FINAL CONSTRUCTION PLANS

BROOKWILLOW VILLAGE

CITY OF GRAND JUNCTION, COLORADO

REVISED PER CITY SEWER DESIGN 1-20-06
REVISED PER CITY OF GRAND JUNCTION COMMENTS 12-22-05
CITY OF GRAND JUNCTION COMMENTS 11-15-05
CITY OF GRAND JUNCTION COMMENTS 8-19-05
DRAWING NO. 1 OF 45 — 2005-145 — 8/19/05 — T1-BROOKWILLOW

GR2

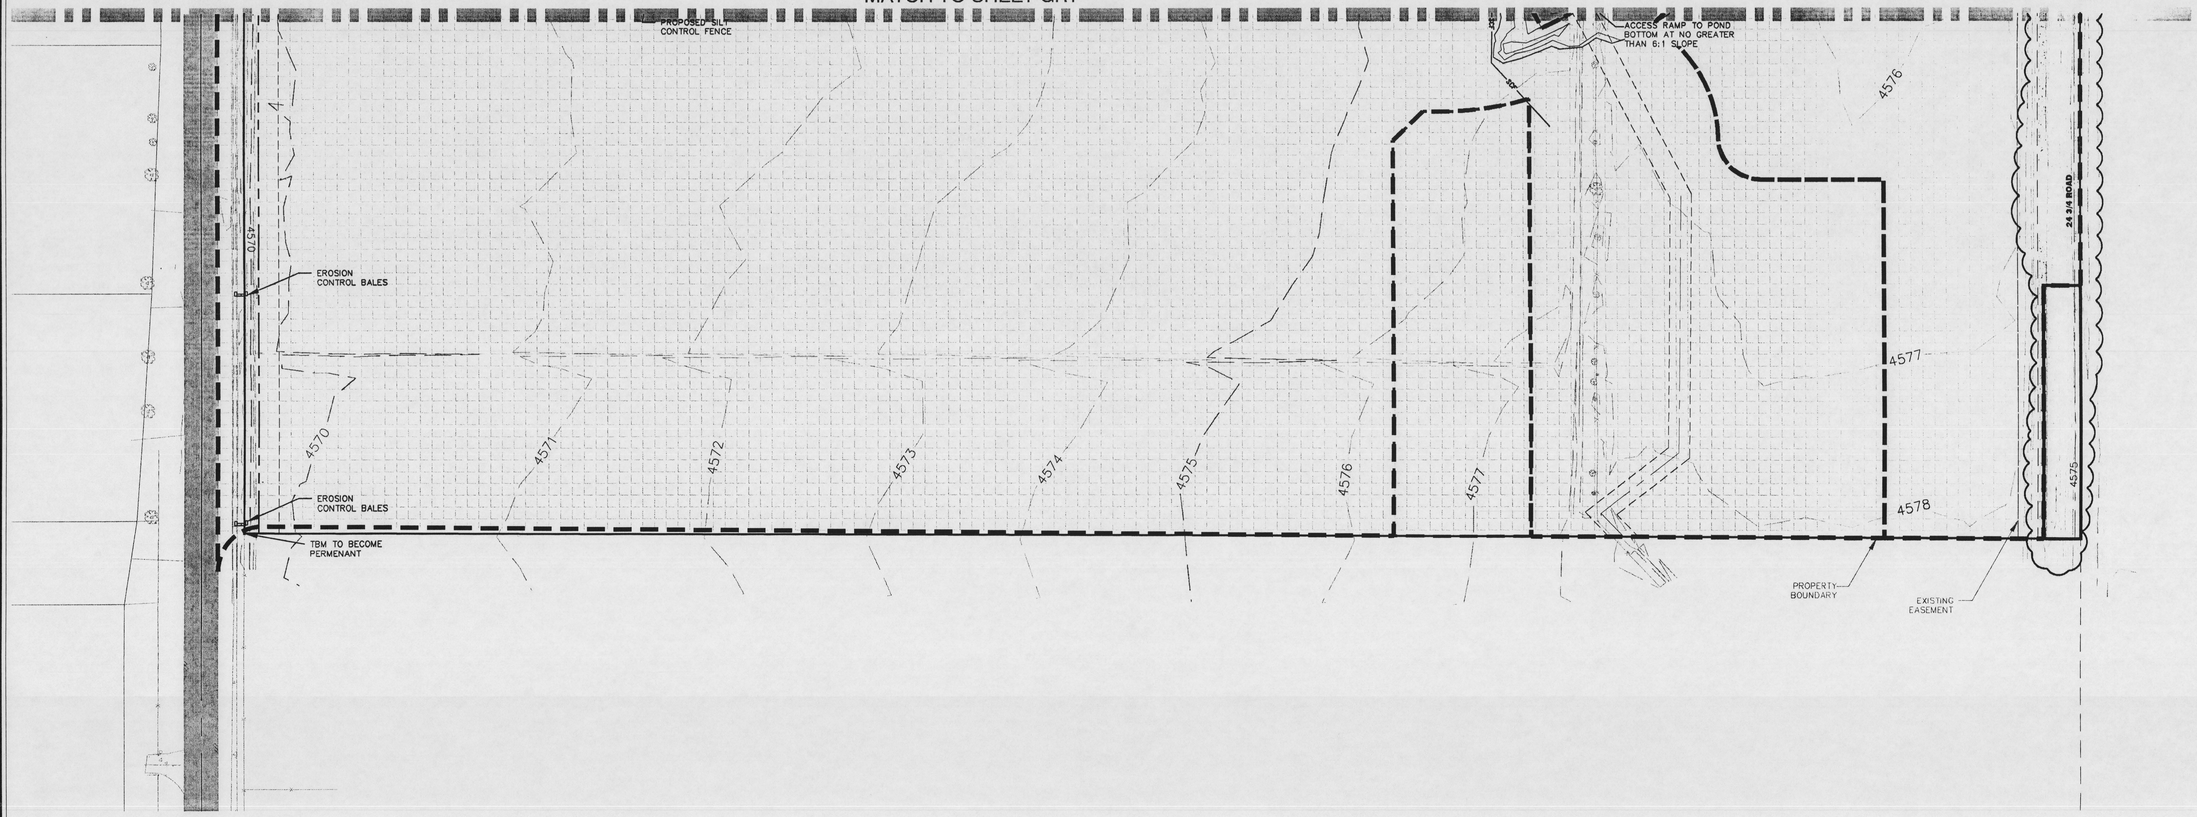
REVISION ON THIS SHEET: SHIFTED 24 3/4 ROAD TO THE WEST 4'

SP-1

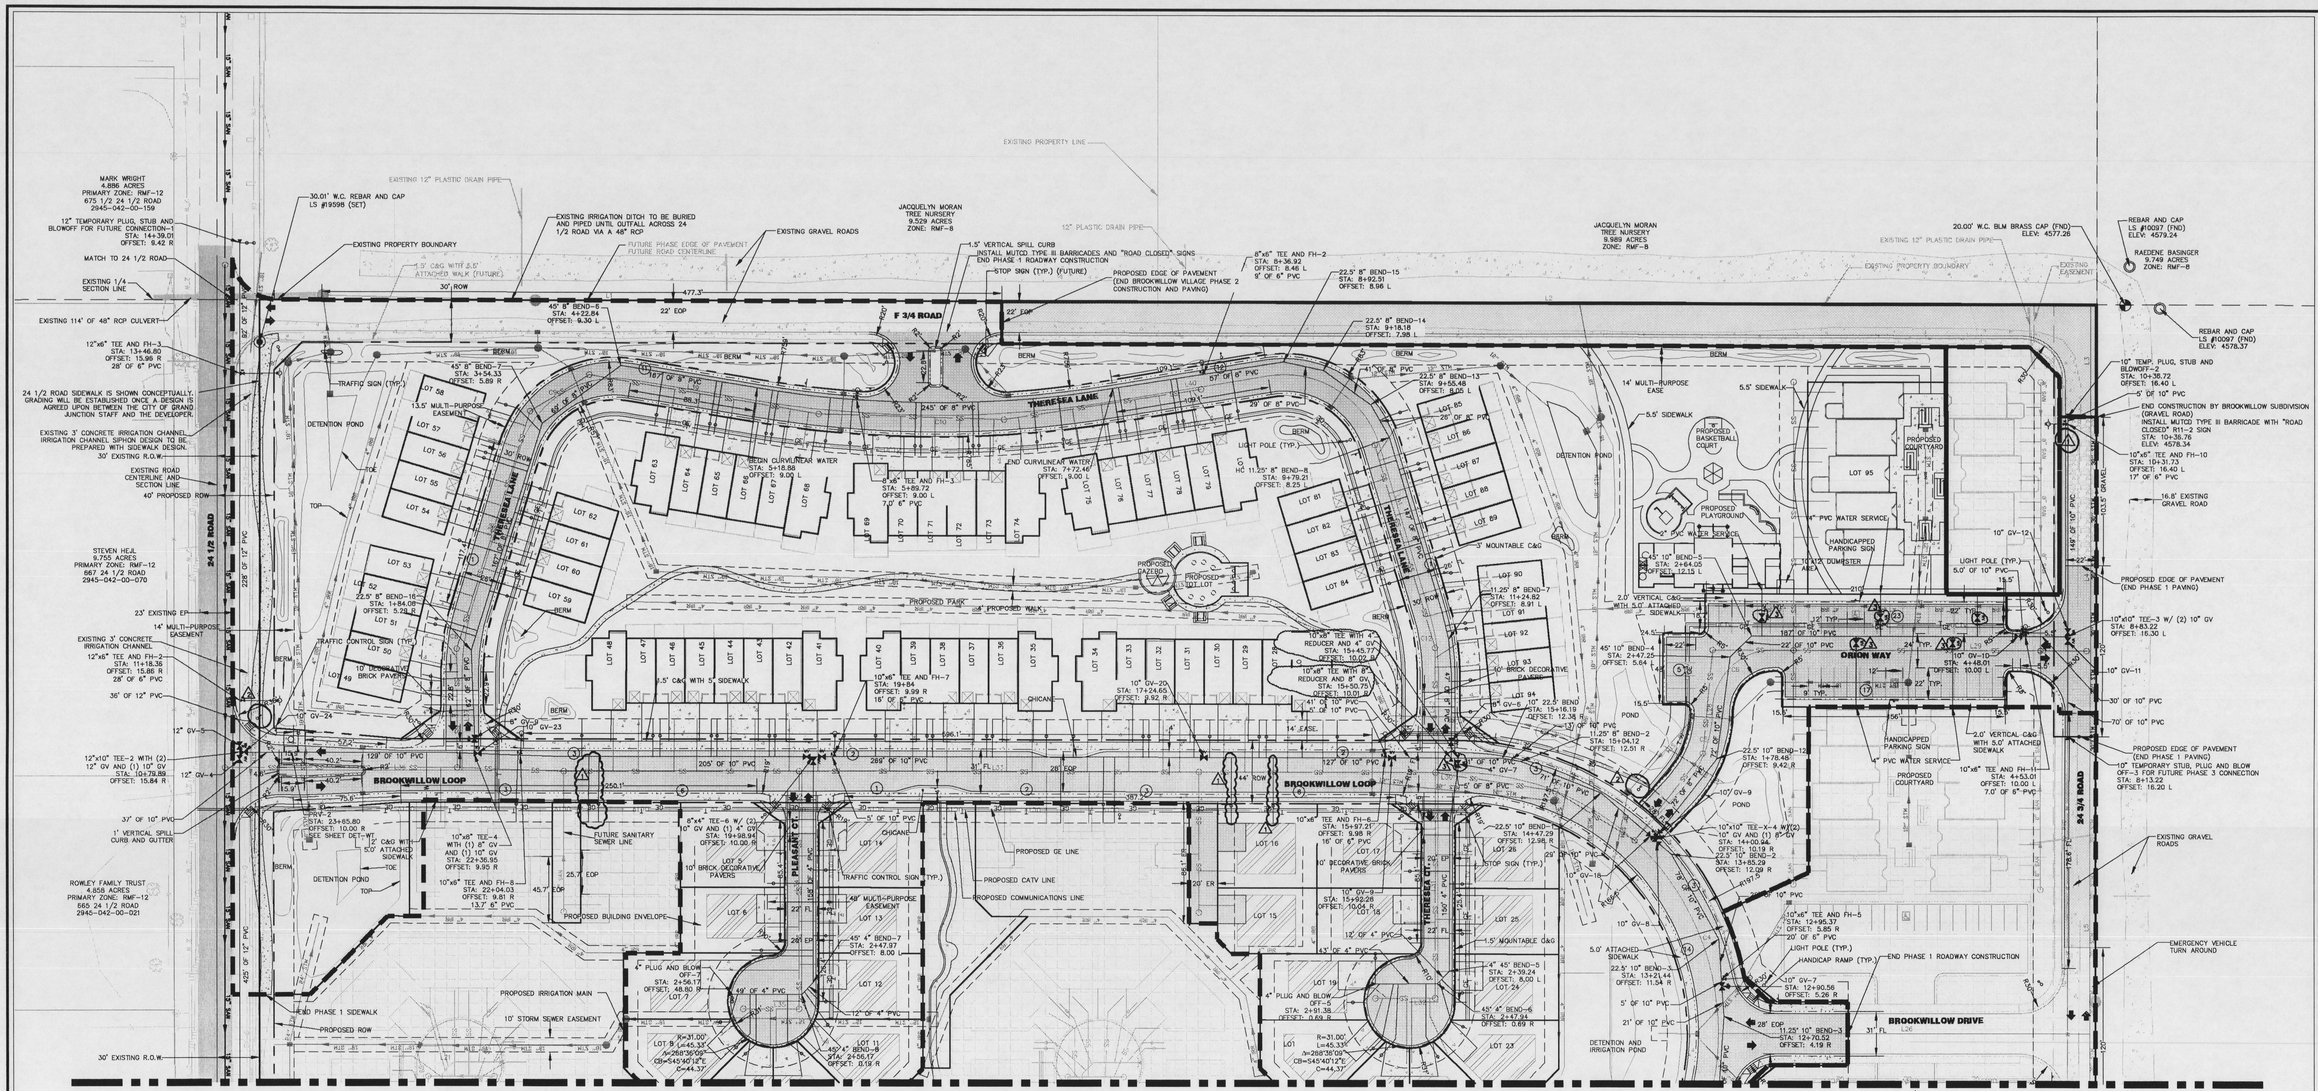
REVISIONS THIS SHEET INCLUDE:
1. CHANGED WATER SERVICE LOCATIONS AND REMOVED 4" WATER LINE PER UTE WATER COMMENTS.
2. REMOVED GATE VALVE PER UTE WATER COMMENTS.
3. MOVED GATE VALVE LOCATIONS PER UTE WATER COMMENTS.
4. CHANGED PHASE OF F 3/4 ROAD.

PPRD-2

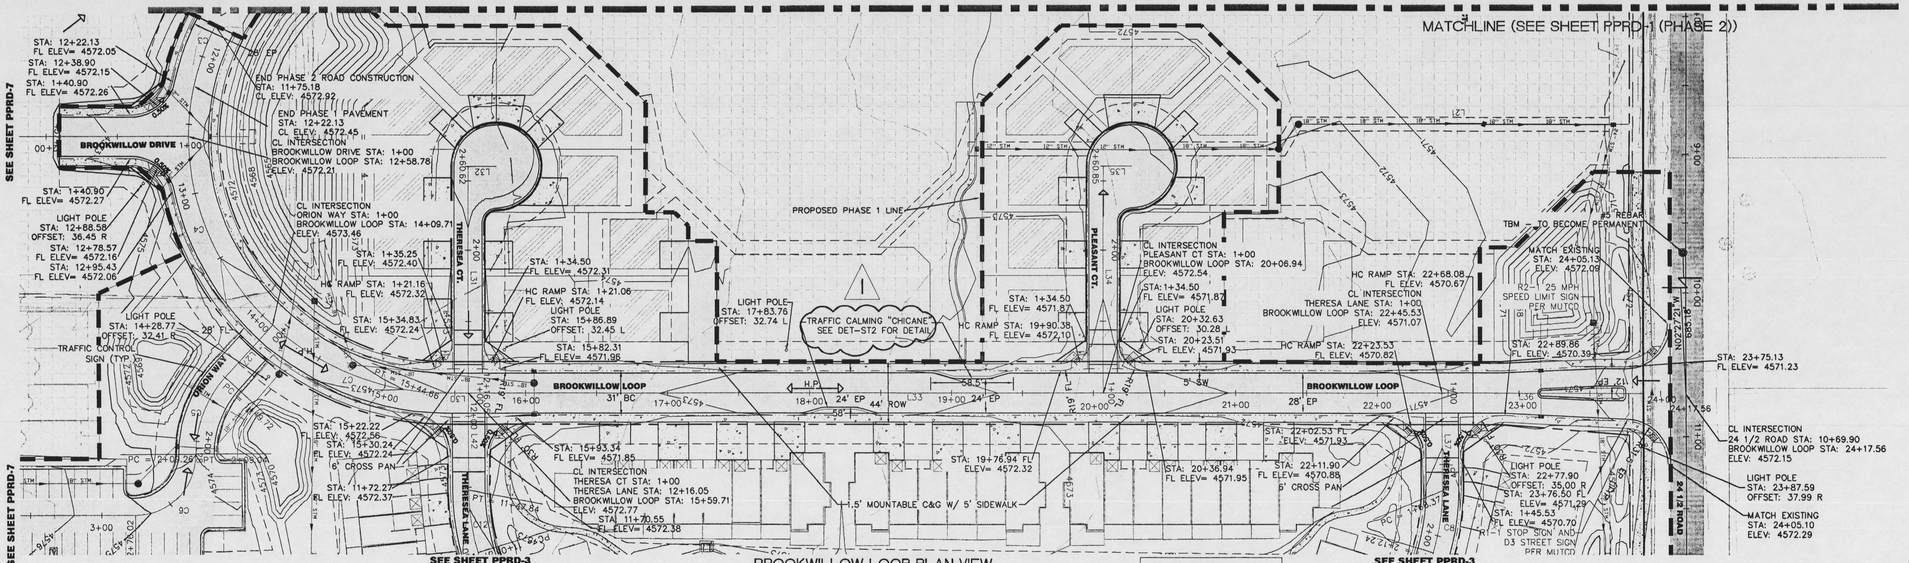
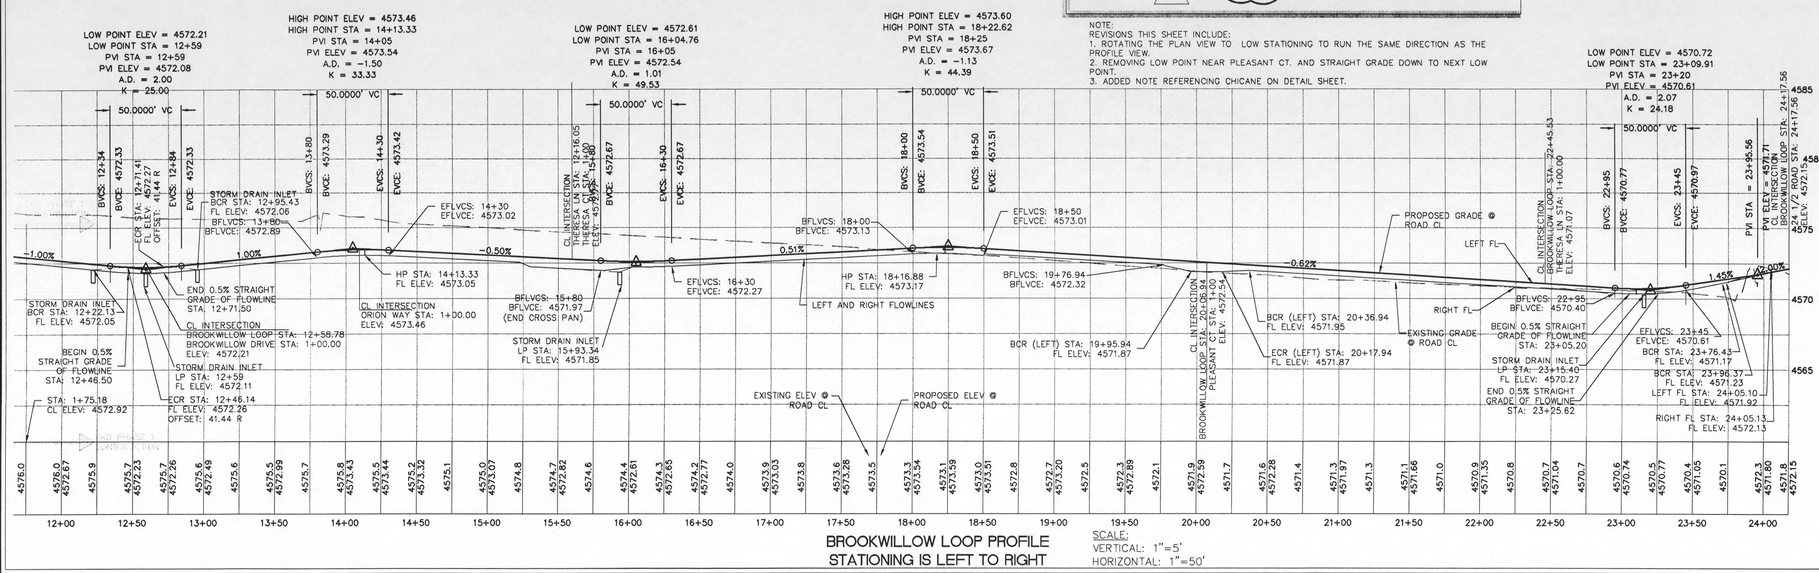
NOTE:
REVISIONS THIS SHEET INCLUDE:
1. ROTATING THE PLAN VIEW TO LOW STATIONING TO RUN THE SAME DIRECTION AS THE PROFILE VIEW.
2. REMOVING LOW POINT NEAR PLEASANT CT. AND STRAIGHT GRADE DOWN TO NEXT LOW POINT.
3. ADDED NOTE REFERENCING CHICANE ON DETAIL SHEET.

PPRD-3

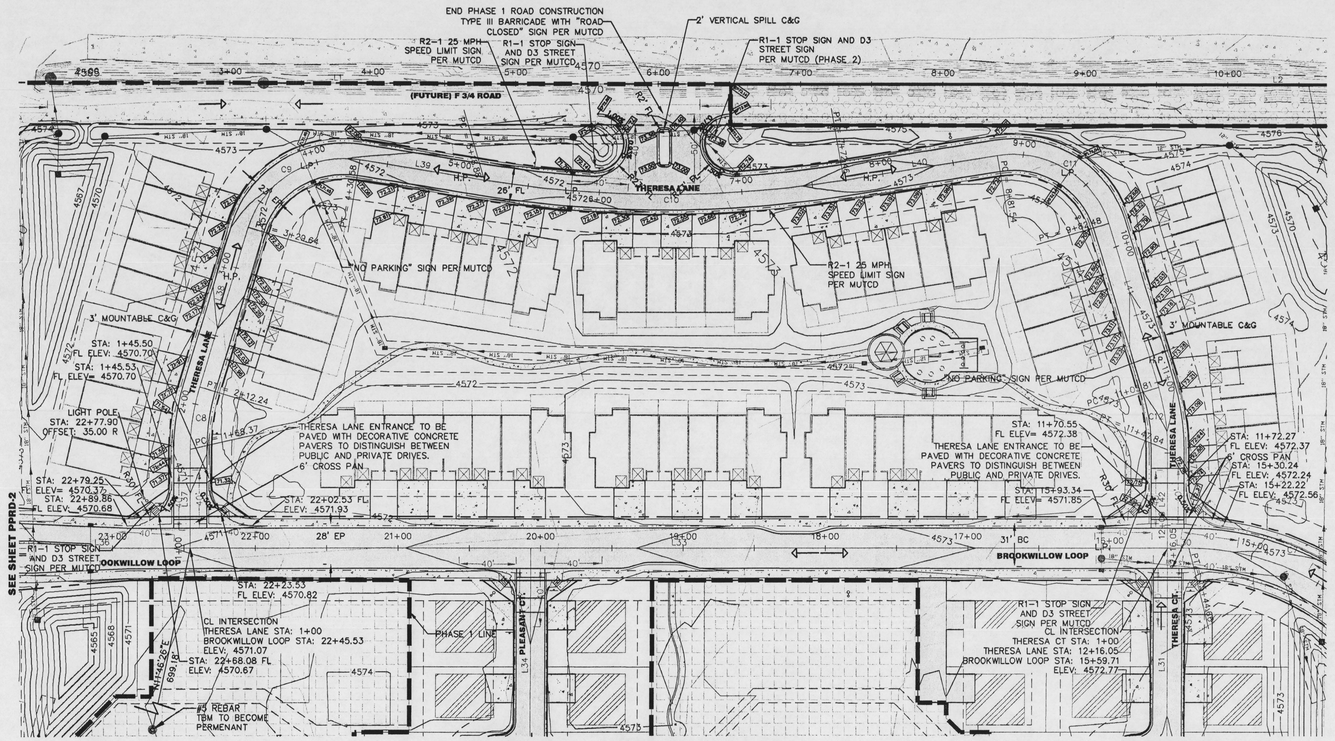
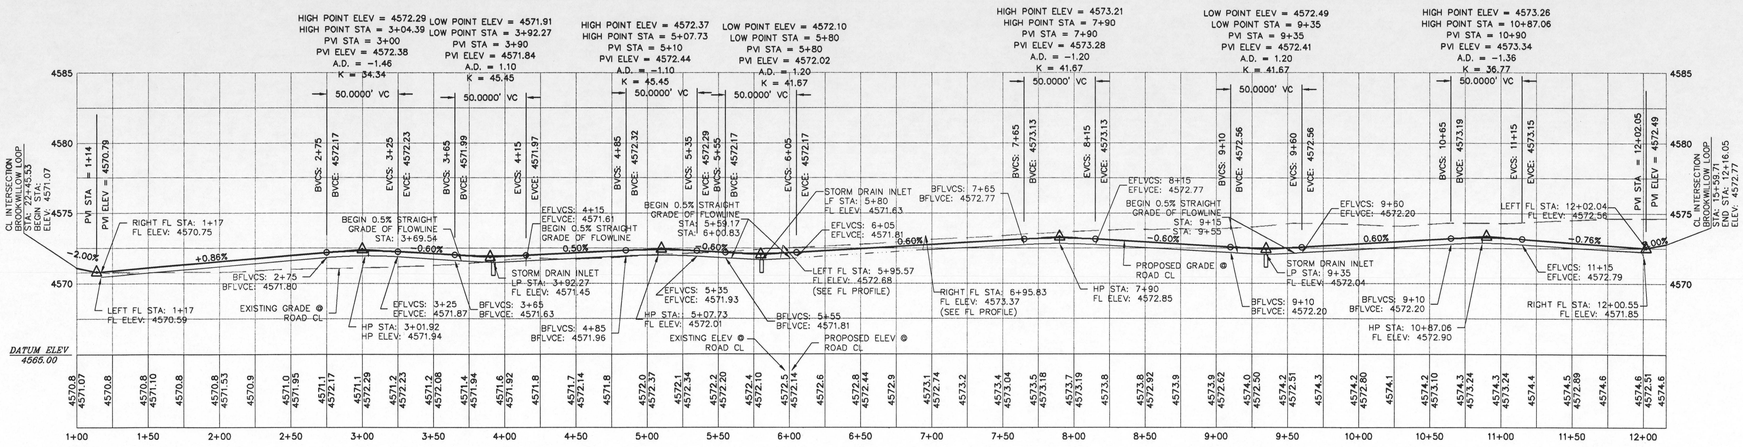
11. REVISIONS ON THIS SHEET INCLUDE CHANGING GRADING ON BROOKWILLOW LOOP AND THERESA LANE INTERSECTION AND ADDING "NO PARKING" SIGNS.

PPRD-5

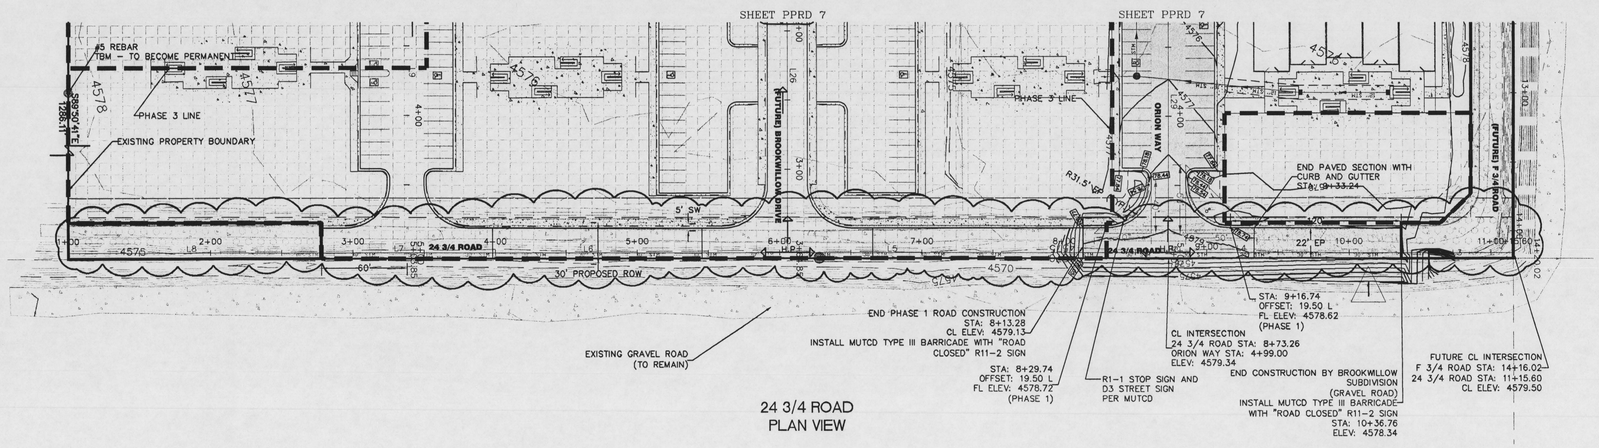
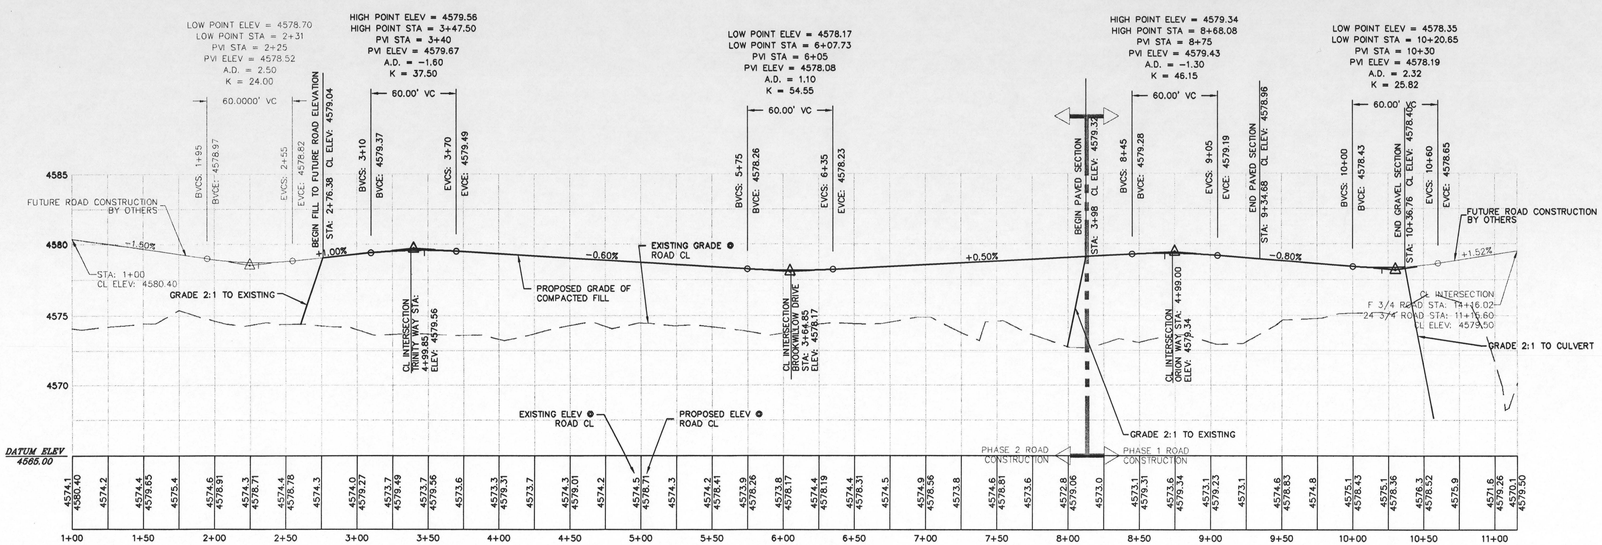
NOTE RVISION THIS SHEET:
SHIFTED 24 3/4 ROAD TO THE WEST 4' AND REGRADED

PPRD-7

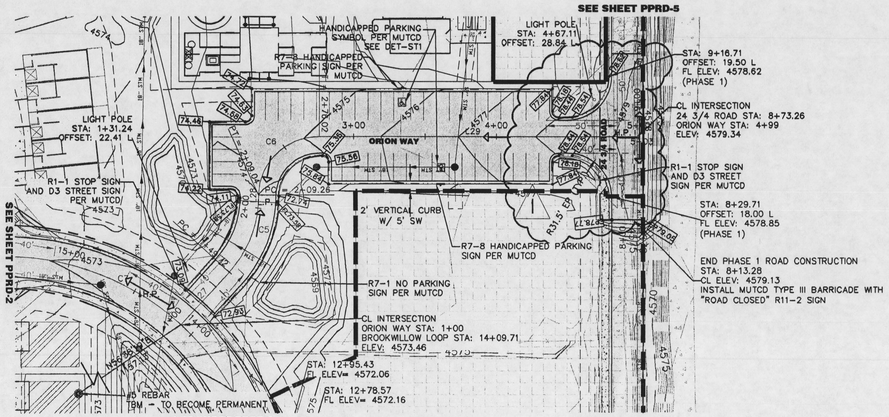
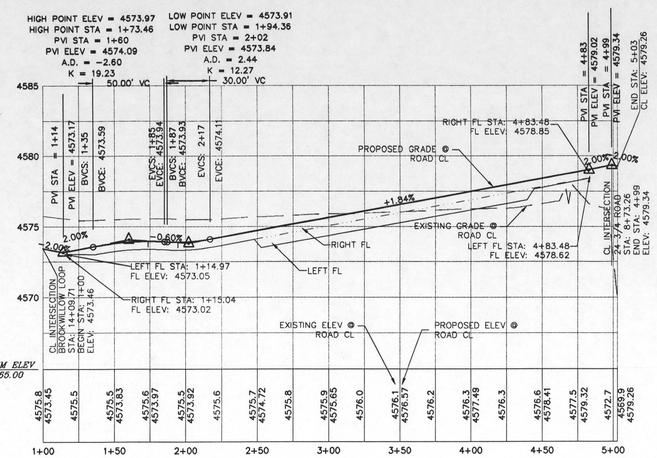
REVISION:
1. SHIFTED 24 3/4 ROAD WEST 4 FEET, CHANGED INTERSECTION WITH ORION WAY AND GRADE OF ROAD.
2. ADDED TIE TO BENCHMARK.

PPRD-9

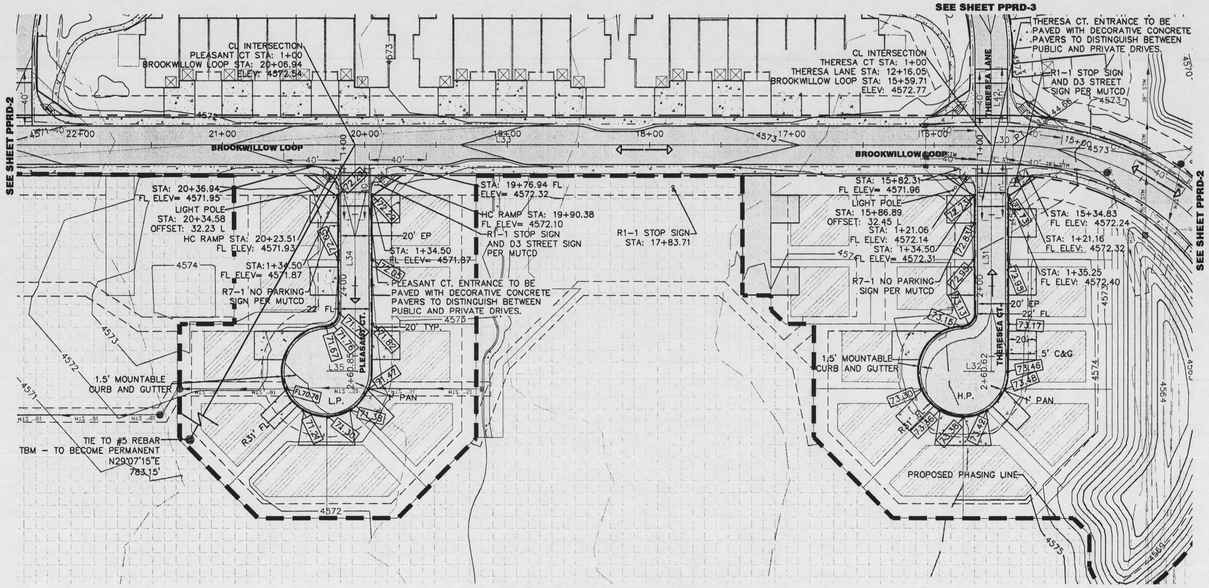
11. REVISIONS PER THIS SHEET: ADDED REFERENCE TO DETAIL SHEET FOR CHICANE.
